Service Information

Category M	Repair Guidance	Ref. No. R102/15	Page 1 of 3
Coverage <input type="checkbox"/> Distributor only <input checked="" type="checkbox"/> Please inform your dealers		Date Issued October 15, 2015	
Please convey this information to your <input type="checkbox"/> Director <input checked="" type="checkbox"/> General Manager <input checked="" type="checkbox"/> Warranty Dept. <input checked="" type="checkbox"/> Parts Dept. <input checked="" type="checkbox"/> Training Dept. <input checked="" type="checkbox"/> Field Rep.		Date Revised	
Applicable Model MX-5 (ND)		Applicable Countries or Specifications Worldwide

Subject: Creak noise from vehicle underneath at the rear when clutch is engaged quickly or the vehicle accelerating/decelerating rapidly

Nuts

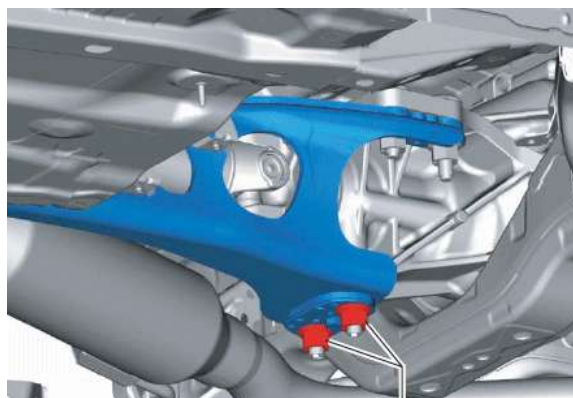
1. Lift up the vehicle.
2. Loosen two mounting nuts of the PPF in figure until they do not touch seating.

Stud bolts

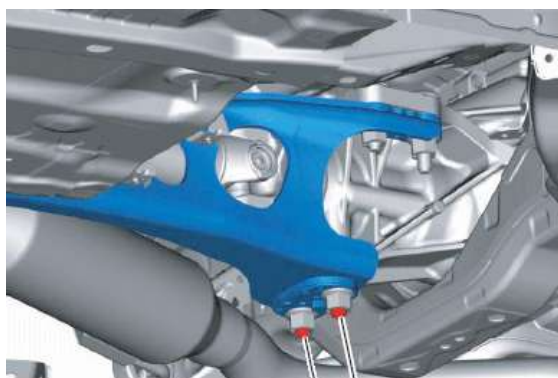
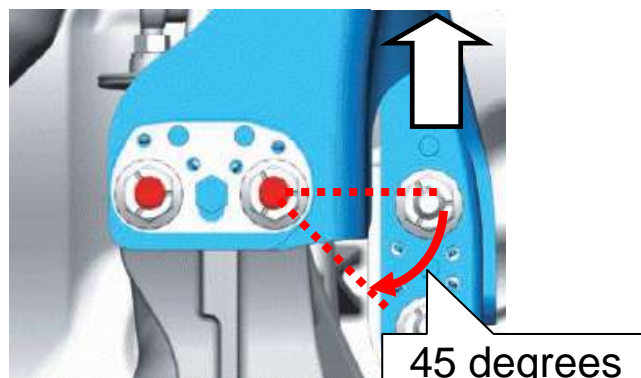
3. Tighten two stud bolts of the PPF in figure for 45 degrees.

45 degrees

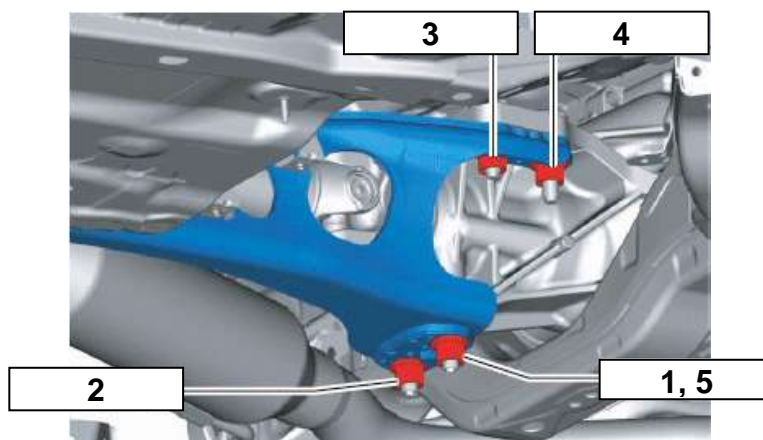
4. Tighten the four mounting nuts of the PPF in the numbered sequence shown below.

Note: Tightening torque

182 - 200 N·m {18.6 - 20.4 kgf·m, 134 - 148 ft·lbf}
